**Overview of India's concerns
Presentation to
GTR - BR members
for the 6/MCGTR/Informal meeting**

**6th - 7th June 2006
NHTSA Office, Washington DC**

**Presentation by
A. Akbar Badusha
&
S. Ramiah
(V. M. Manel & R. Venkatesan
Regret absence)**

6. Proposal from India

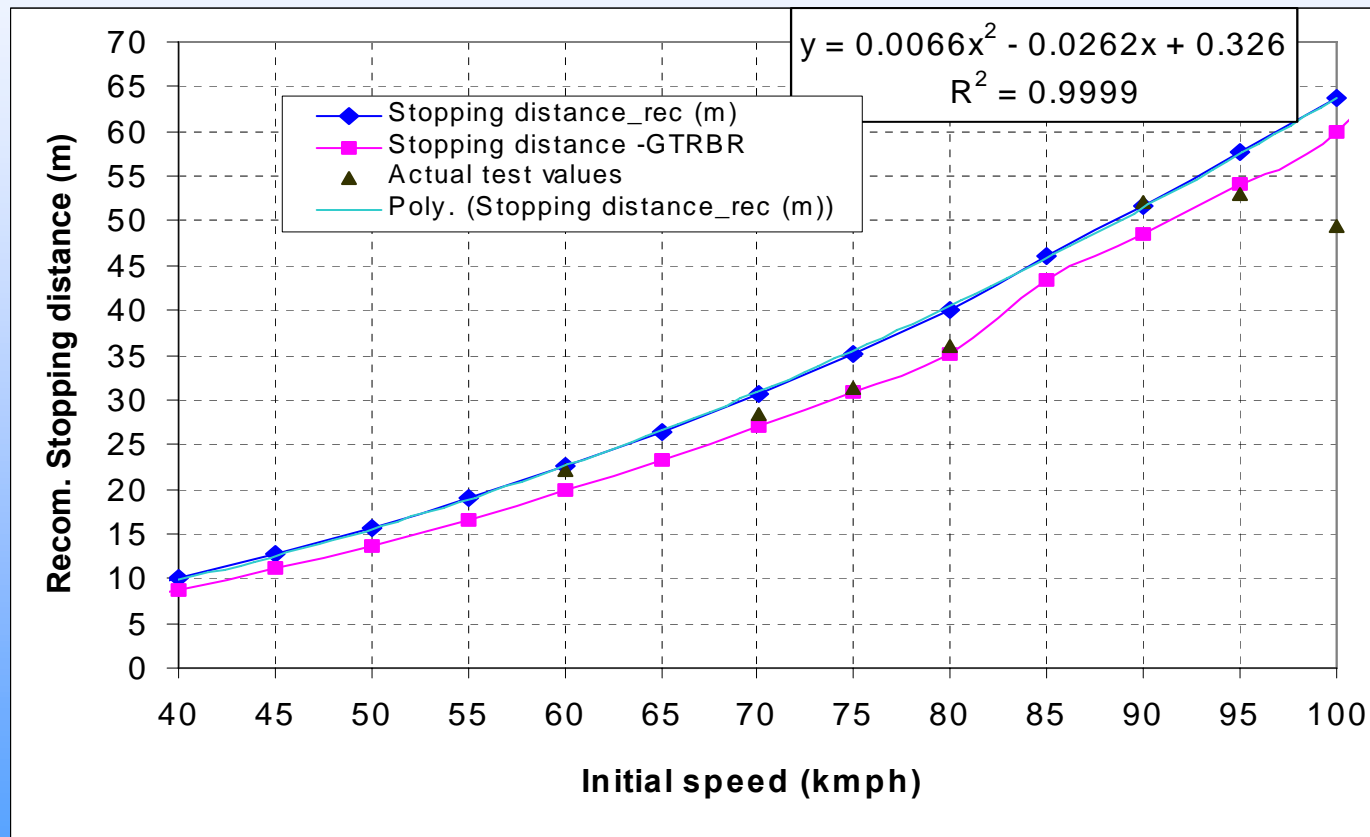
- India had earlier proposed that

$S \leq 0.1V + 0.0067 V^2$ for vehicle with $V_{\max} \leq 125$ km/h and

$S \leq 0.0060 V^2$ for vehicle with $V_{\max} > 125$ km/h.

- Subsequent to the data collected, India puts forward an alternate proposal, arrived after considering various factors of total braking coefficient etc.

$S \leq 0.0066 V^2 - 0.0262 V + 0.326$

- The stopping distance requirement as per the above formula is stringent than ECE by about 29% @ 60 km/h.
- As per the above formula, the deviation from GTR is about 12% for speeds between 40 km/h to 80.5 km/h and 6% for speeds above 80.5 km/h.

1. Drop in total braking coefficient

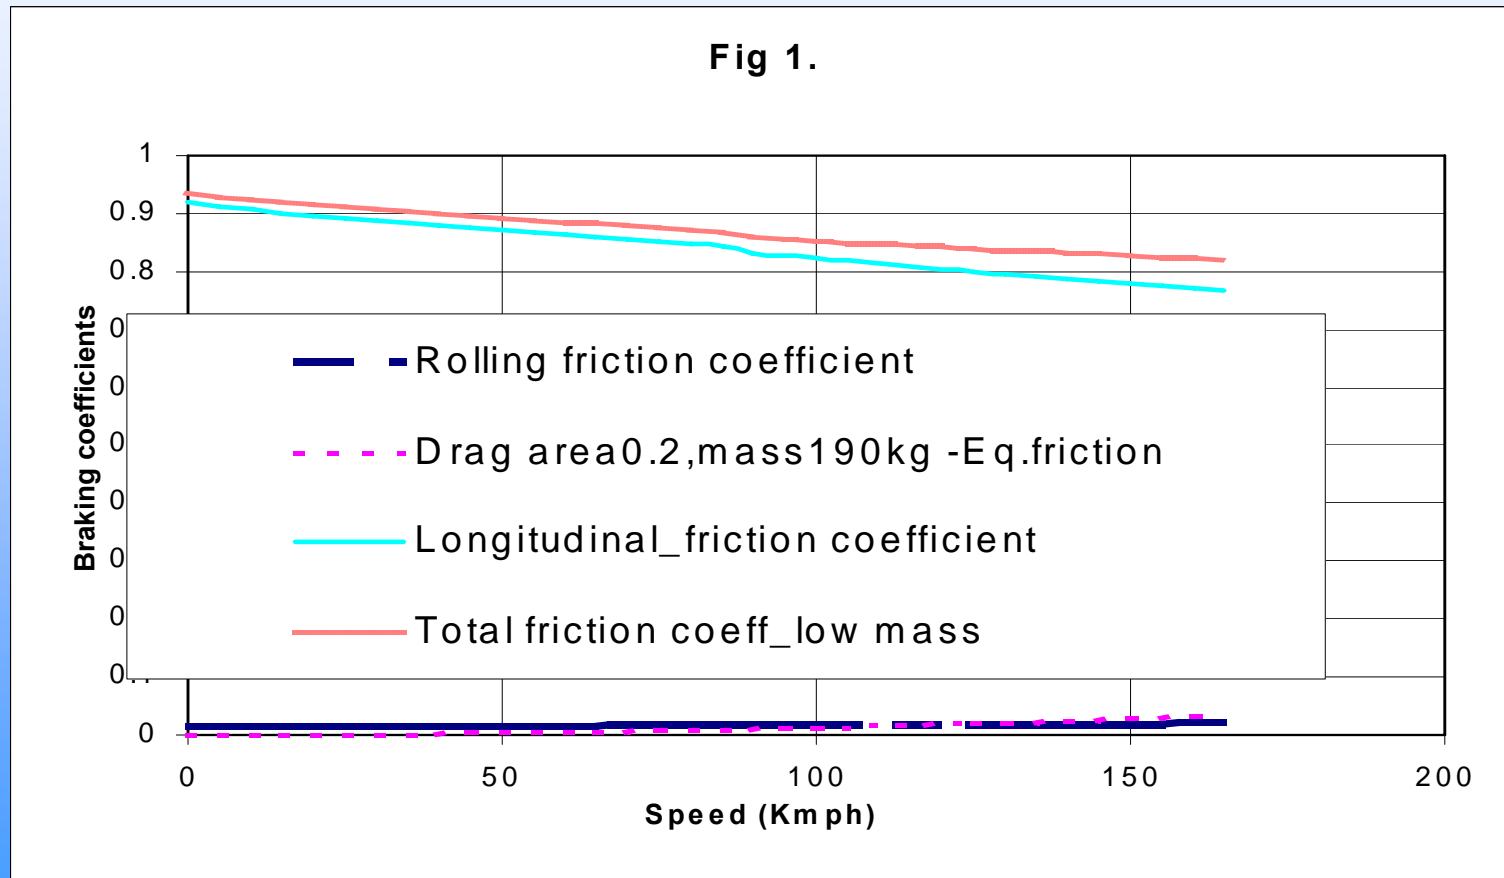
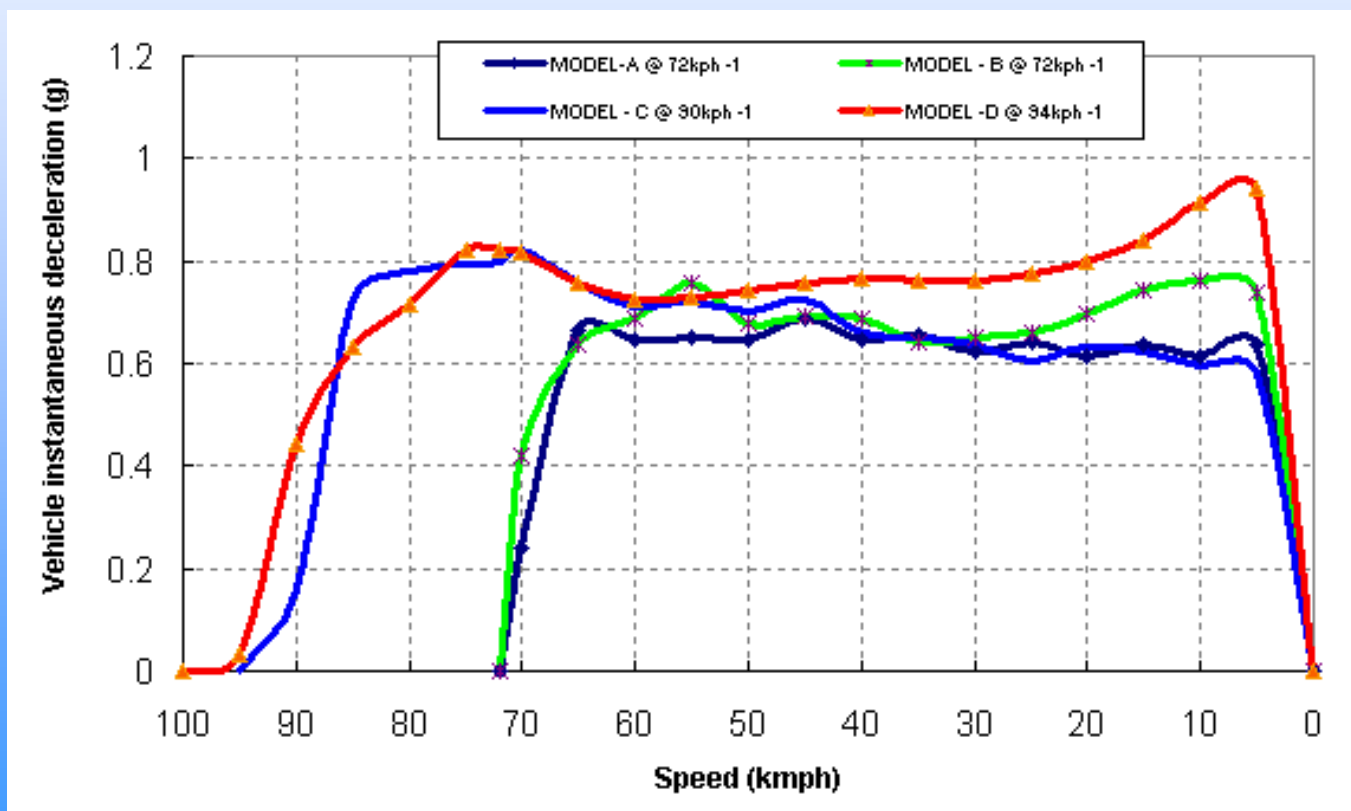
Based on the published data

- Drop in sliding friction is @ 14% from 40 km/h to 160 km/h.
- The overall drop considering the effect of rolling and aerodynamic coefficient is only 9%.

3. Change in deceleration requirements between test speeds 40 km/h to 160 km/h

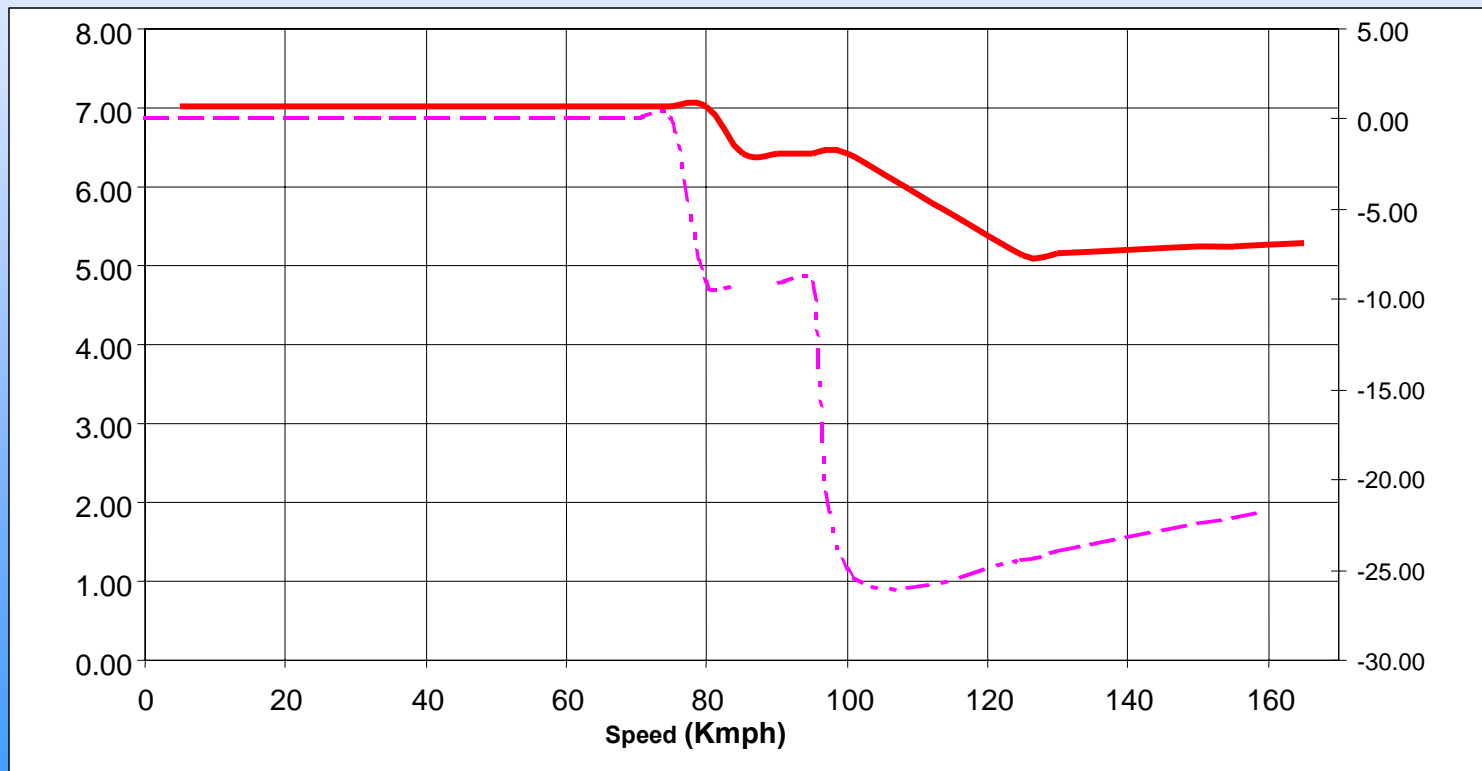
From this Figure as per GTR requirement

- The average deceleration requirement is 7.01 m/sec^2 up to test speed 80.5 km/h.
- The decrease in the deceleration value is 12% between 80.5 km/h to 100 km/h and about 21% for 100 km/h to 160 km/h when tested as per clause 4.5 of the draft GTR
- The drop in the total braking coefficient is only 9% as shown in the SI no.1.
- Any vehicle falling between 40 km/h to 80.5 km/h has to meet more stringent requirement.

4. Laden CG Height / Wheel base contribution

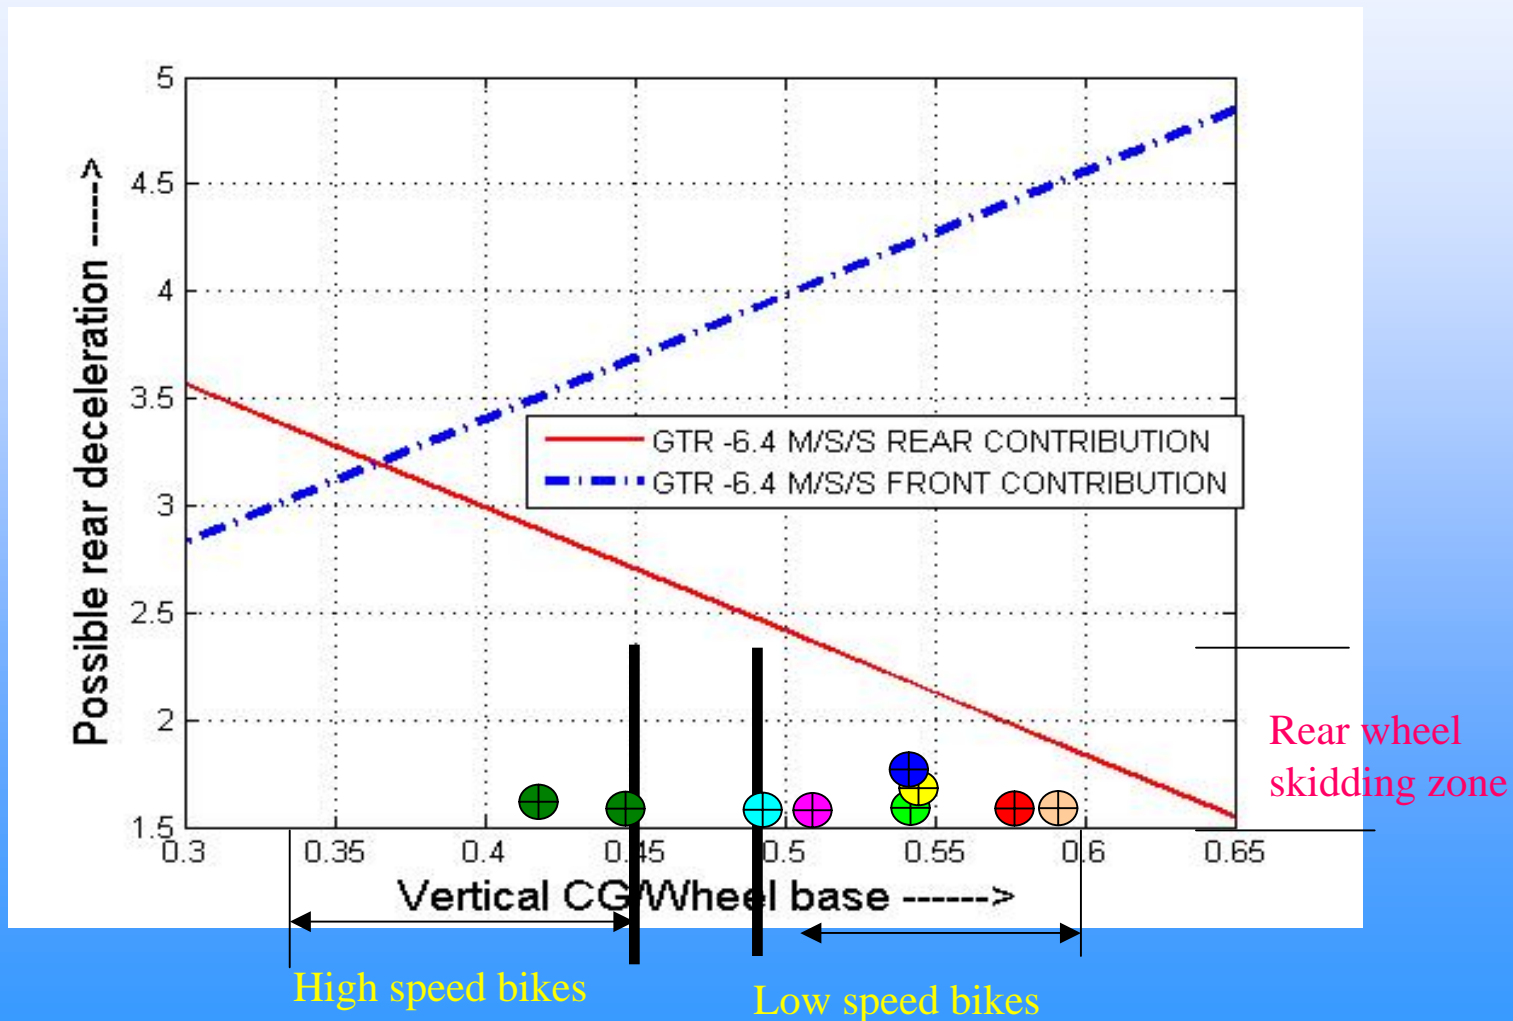
- Majority of Indian motorcycles have shorter wheel base due to riding style and for better slow speed maneuverability.
- The ratio of height of CG to wheelbase (h/p) is higher in these motorcycles (0.5 – 0.6) as compared to high end bikes (0.4 – 0.45). This results in larger load transfer on the front brake and rear brake is found to be less effective when tested as per Clause 4.4.3 of the GTR.
- In high end motorcycles with larger wheel base, the load transfer from the rear wheel to the front wheel is comparatively lesser and hence produces better deceleration.
